SUBJECT: ADDITION OF MAXIMUM AVERAGE PLANAR LINEAR HEAT GENERATION RATE
LIMITS (TAC 60449)

Re: Nine Mile Point Nuclear Station, Unit No. 1

Amendment No. 81
License No. DPR-63

ATTACHMENT TO LICENSE AMENDMENT NO. 81

Figure 3.1.7f Maximum Allowable Average Planar LHGR Applicable to P8DRB299 and Future Reload Fuel as described in Reference 8.

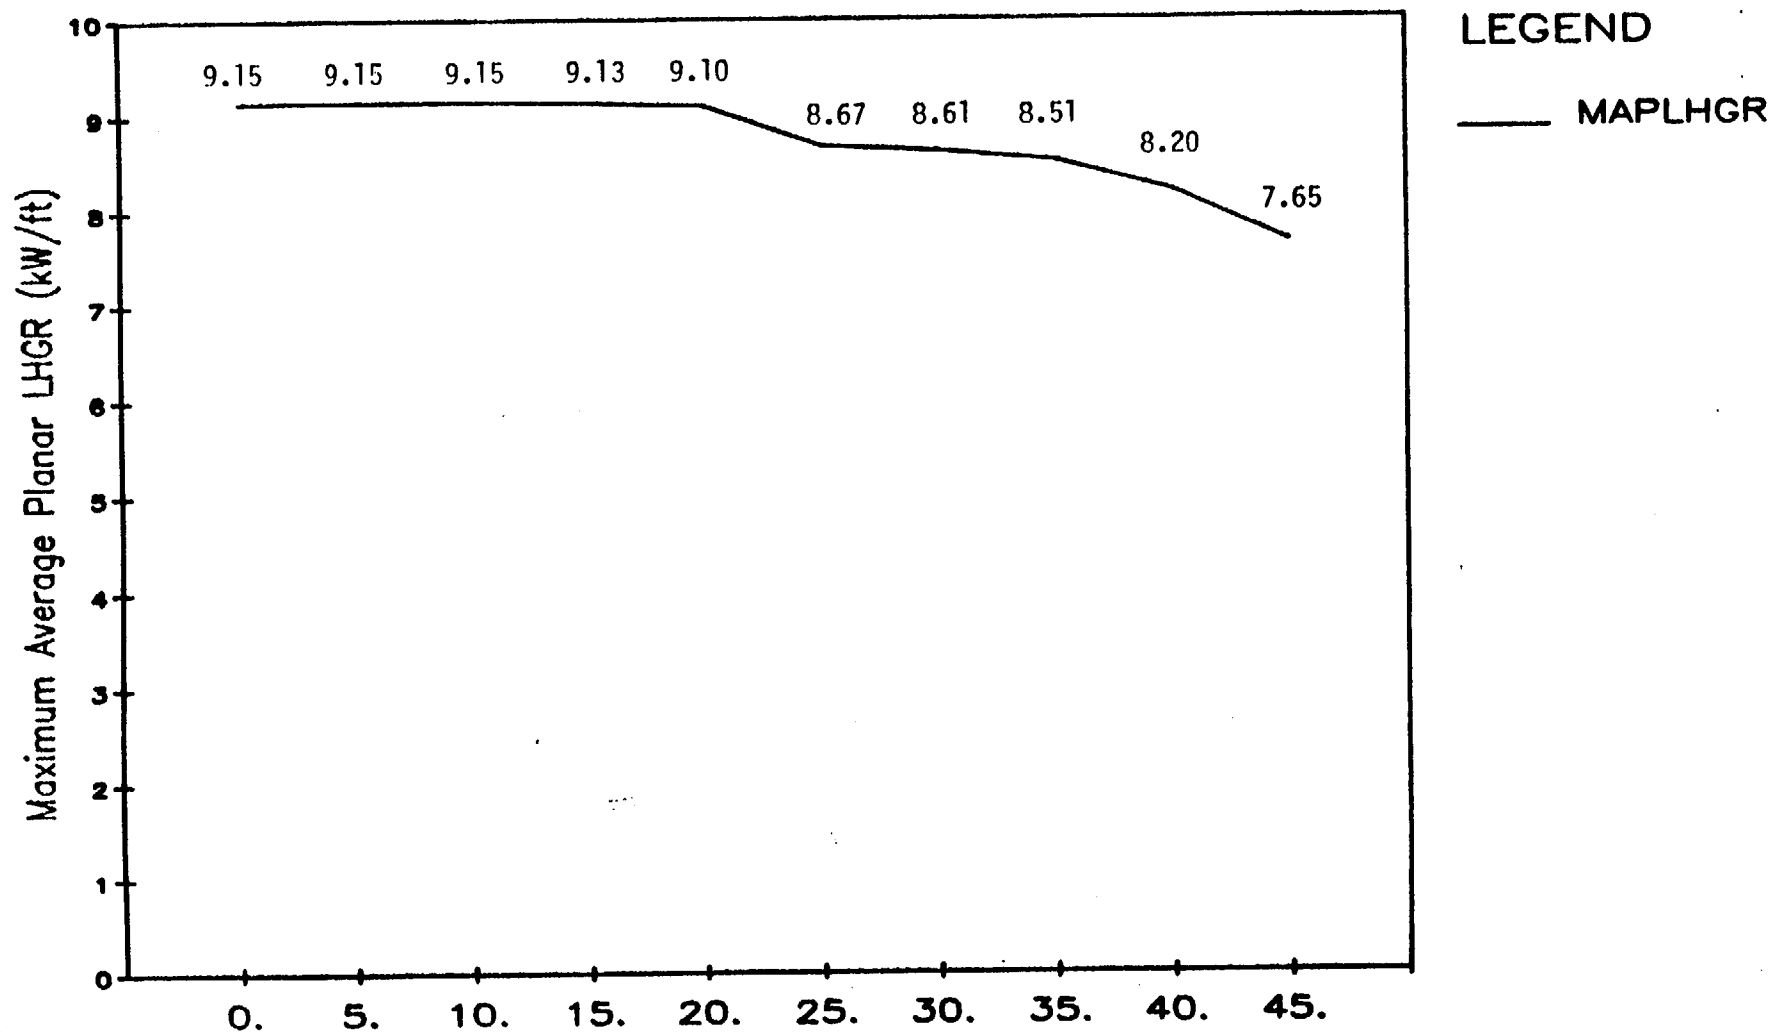
The proposed Technical Specification changes to Section 3.1.7 and Figure 3.1.7(f) reflect the addition of the MAPLHGR limits for the General Electric fuel bundle, type P8DRB299. These limits were calculated using the same approved General Electric methods used for the present fuel type P8DNB277. The licensee has analyzed the loss of coolant accident response of the P8DRB299 fuel and results for the type P8DRB299 fuel analysis demonstrate that (1) the peak cladding temperature and maximum oxidation fraction limits are approximately the same as for previous fuel types; (2) the loss of coolant accident response is approximately the same as for the fuel currently used; and (3) the peak cladding temperature and the maximum oxidation fraction limits are within the limits set by 10 CFR 50.46. Therefore, the proposed amendment to Section 3.1.7 and Figure 3.1.7(f) of the Technical Specifications to reflect the addition of the MAPLHGR limits for fuel type P8DRB299 is acceptable.

During power operation, the APLHGR for each type of fuel as a function of average planar exposure shall not exceed the limiting value shown in Figures 3.1.7a, 3.1.7b, 3.1.7c, 3.1.7d, 3.1.7e and 3.1.7f. If at any time during power operation it is determined by normal surveillance that the limiting value for APLHGR is being exceeded at any node in the core, action shall be initiated within 15 minutes to restore operation to within the prescribed limits. If the APLHGR at all nodes in the core is not returned to within the prescribed limits within two (2) hours, reactor power reductions shall be initiated at a rate not less than 10% per hour until APLHGR at all nodes is within the prescribed limits.
